Delegated Report

Householder Planning Application

Planning Application No: 20230589

Location: 373 Valley Drive Gravesend Kent DA12 5TA

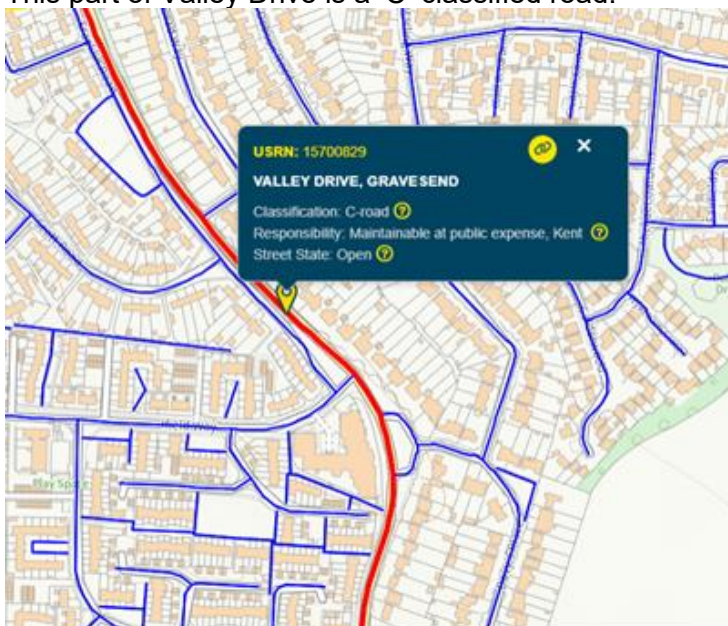
So ignoring the need to turn on site, the applicant should be able to devise a parking plan for two Vehicles, which is all parking guidance requires, however the swept path needs to be based on a BMW Series 5 or similar large family saloon. The parking space perpendicular to the highway would need to be a minimum of 3.9 metres wide by 6 metres deep to provided pedestrian access to the steps to the property. The space parallel to the highway requires a minimum width of 3 metres and a length of 6 metres to comply withb guidance issued by Kent County Council in terms of vehicle crossover requirments. This gives a total garden width requirement 9.9 metres which is less than the 11 metres available if the existing side driveway is to be abandoned, which drawing A08 and the application form suggests.

All materials used for the driveway should be bound and permeable.

With the increase of bedrooms from 3 to 4, a secure cycle parking space should be provided for the fourth bedroom.

However as presented with the widening of the crossover the application should be refused.

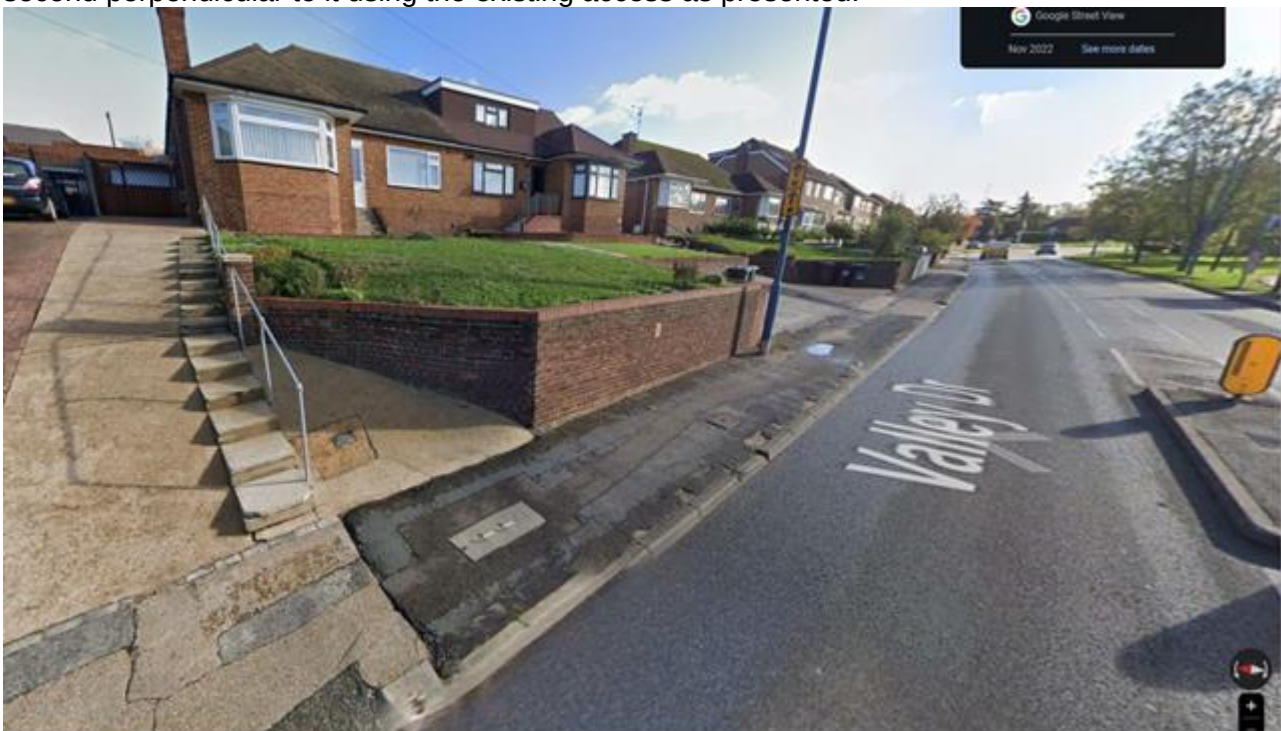
So, considering these requirements, the applicant has space to park one car parallel to the highway and a second perpendicular to it using the existing access as presented.

The proposal would then largely mimic the layout at 375 Valley Drive, although there any second vehicle would have to use the driveway originally provided.
